Independent Verification Memo: WO-01 Pump Module Selection for the Water-Reclamation Transfer Loop

Verification diagram: recomputed energy ranking on the shared acceptance run with eligibility margins; P2 leads at 12 kWh with verified gaps of 40, 44 and 46 kWh.

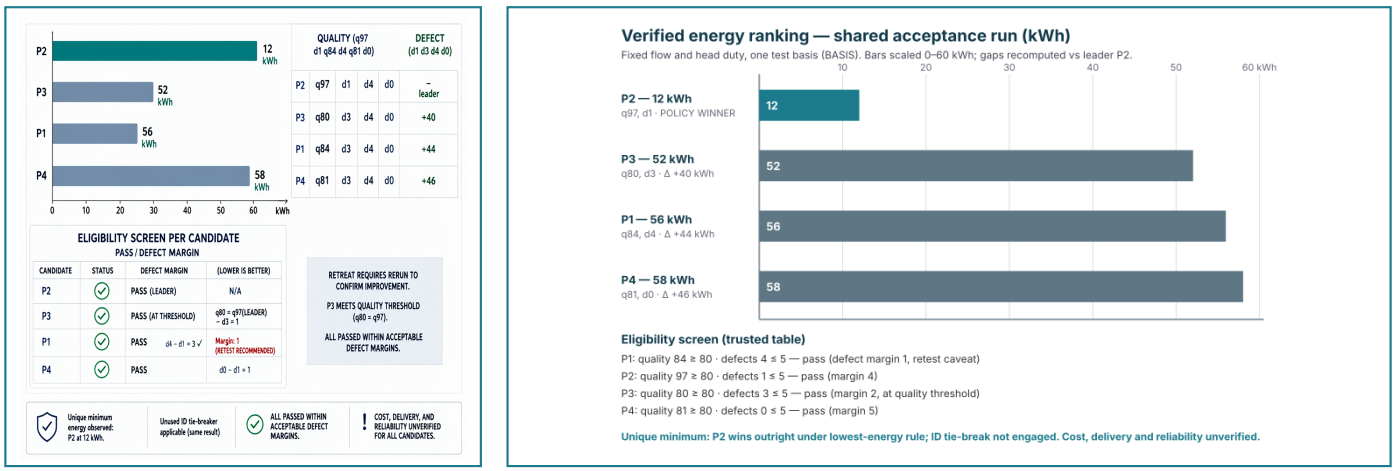
Recomputed from the trusted table alone: P1 quality 84 with 4 defects; P2 97/1; P3 80/3; P4 81/0. Thresholds are quality at least 80 and defects at most 5. Every candidate passes: P3 meets the quality minimum exactly and P2 clears it by 17 points; the defect ceiling is cleared by 1, 4, 2 and 5 counts respectively. P1's one-count defect margin is a robustness caveat — a single retest could disqualify it, though today's record is unaffected. All four modules qualify, so reject_all is not applicable. This matches the delivered report's screening.

The ranking recomputes as 12, 52, 56 and 58 kWh. My independent gap sums: 52−12=40; 56−12=44; 58−12=46 kWh, matching the analyst's figures. Expressed as multiples of the leader's run, P3 is about 4.33×, P1 about 4.67× and P4 about 4.83×. Because the work order states every module serves the same fixed flow and head on one test basis, these differences reflect module efficiency rather than duty or measurement artifacts — a premise I took from the supplied work order, not from the analyst's report. The minimum is unique at 12 kWh, so the lowest-ID tie-break rule is unnecessary. No cost, delivery or maintenance data exists in the supplied facts, so none enters the ranking.

I checked the delivered report's screening, gap sums and recommendation against the sources and found no factual errors or unsupported claims; its flagged open questions are correctly labeled as open, and unverified cost and reliability are correctly excluded. My ballot is P2, because it qualifies (quality 97, one defect) and posts the unique minimum energy of 12 kWh under the written selection rule. This judgment is mine, re-derived from the table; agreement with the analyst reflects convergent arithmetic, not copied conclusions. Handover note for C: record the defect-margin column (P1 margin 1, P4 margin 5) and the three open questions for the next analyst, and keep cost and reliability explicitly out of scope.
